## **TEMPORARY DRAINAGE PROPOSAL (Final)**

APPLICATION SITE OF PROPOSED TEMPORARY  
WAREHOUSE FOR STORAGE OF HARDWARE  
ACCESSORIES FOR A PERIOD OF 3 YEARS AT LOT  
1965 IN D.D.129, LAU FAU SHAN, YUEN LONG,  
NEW TERRITORIES

**Response to Comments on Temporary Drainage Proposal (Issue 1)**

## Appendix C - Proposed Drainage Plan

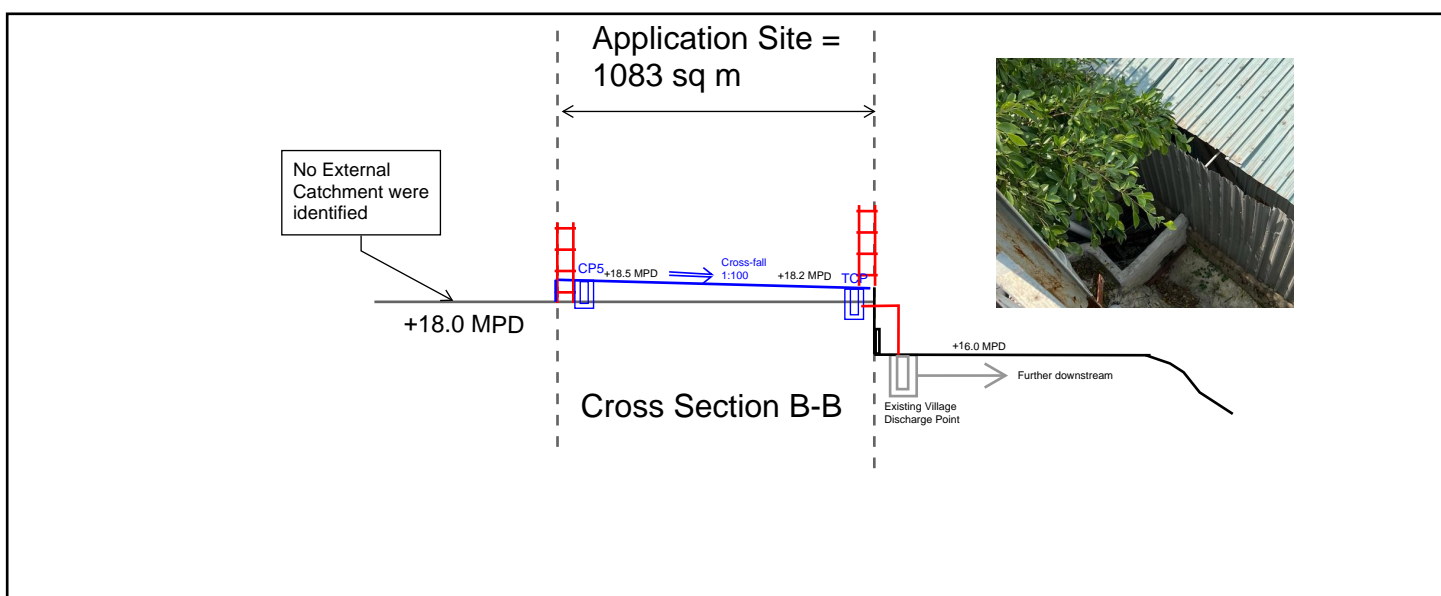
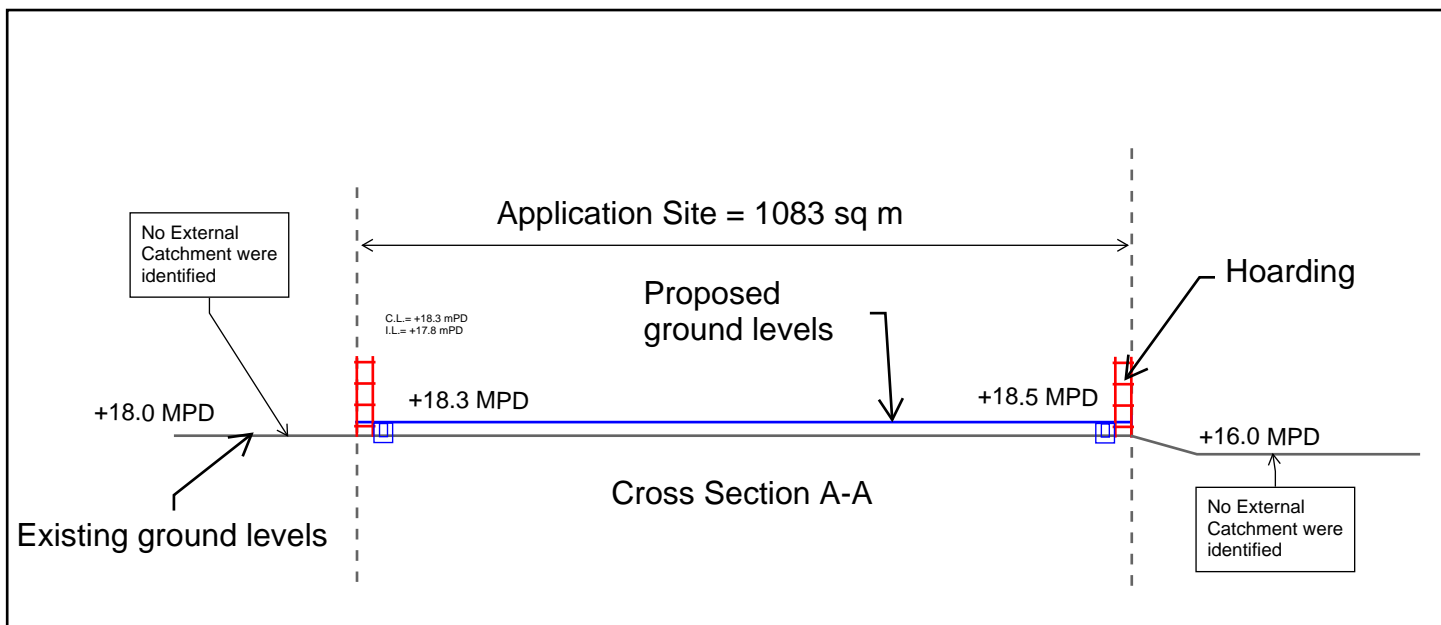
No.	Comments	Response
1.	Peripheral surface channels shall be provided along the site boundary to collect the surface runoff accrued on the application site and to intercept the overland flow from the adjacent lands.	U-channels with 300mm dia. would be provided along the boundary to collect the surface runoff. Please refer to the Appendix C – Proposed Drainage Works.

2.	The proposal should indicate how the runoff (the flow direction) within the site and from the adjacent areas would be discharged to the proposed drainage system	Please refer to the Appendix C – Proposed Drainage Works.

8.	The ground to the north, east and south of the application site is generally/significantly higher. Since the overland flow from the adjacent lands shall be probably intercepted, external catchment shall be considered in the	Based on the site record, since the ground level of application site is generally higher than the adjacent ground surface. No external catchment shall be considered in

10.	Sand trap or provision alike should be clearly indicated on the proposed drainage plan and provided before the collected runoff is discharged to the public drainage facilities.	Noted and agreed. Please note that catchpit with Sand Trap (Refer Drawing No.C2406/1) are indicated in the Appendix C.

12.	The cover levels and invert levels of the proposed u-channel, catchpits/sand traps should be shown on the drainage plan.	Cover levels and invert levels are provided in the proposed drainage works as shown in Appendix C.

13.	Consideration should be given to provide grating tor the surface channels.	Noted with thanks. Cast iron grating would be provided underlaid the main entrance as specified in Appendix C refer to CEDD's standard drawings C2412E.

Site Photo 1 for Electric Room

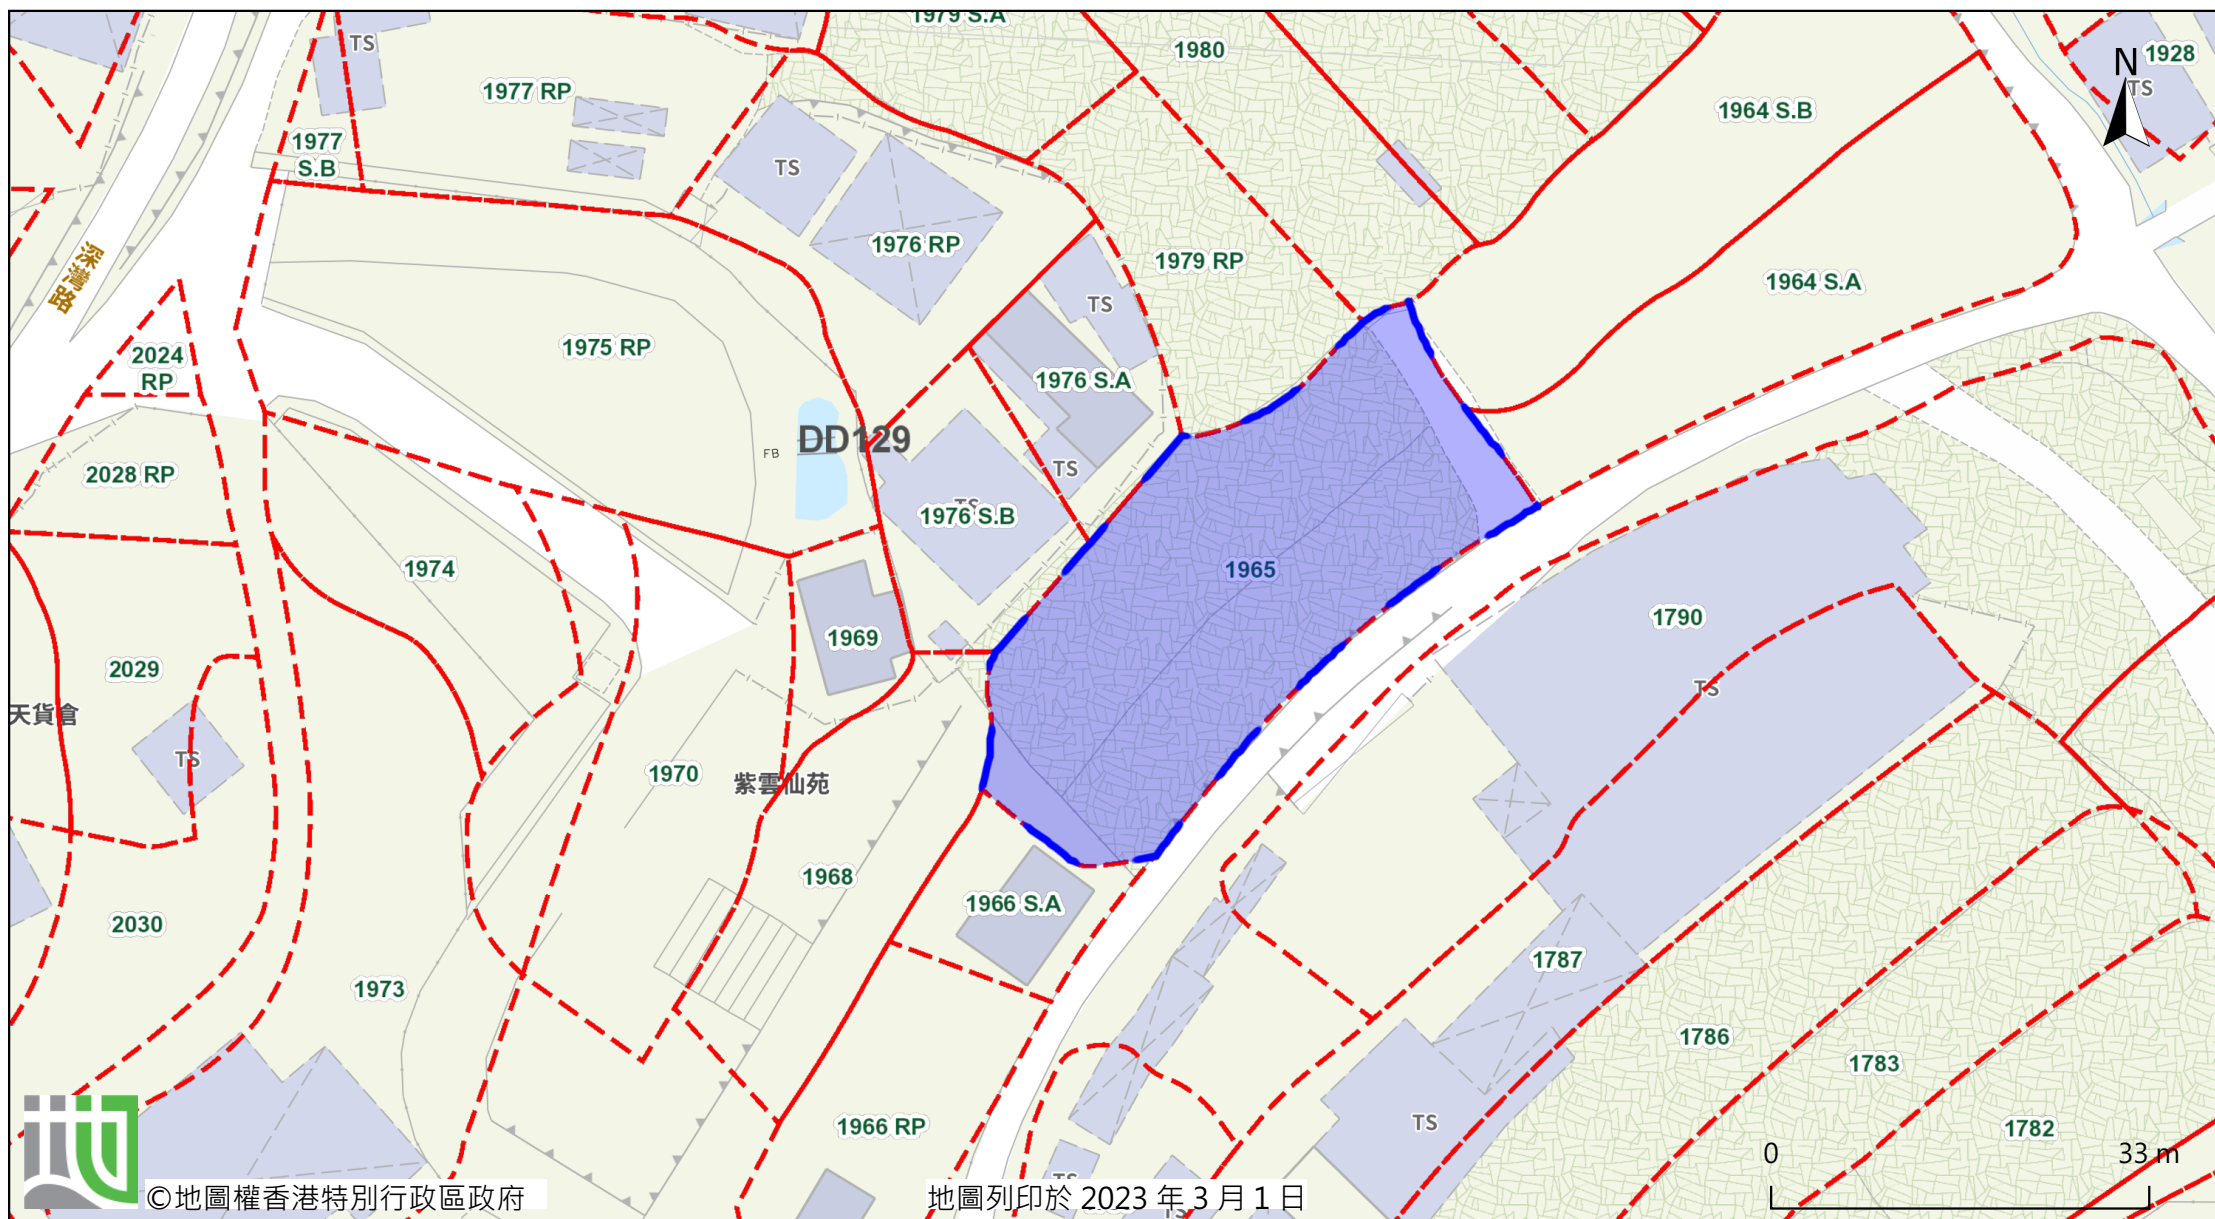
Please be advised that the electric room would not clash with the proposed u-channel, you may refer to the site photos for the clarification
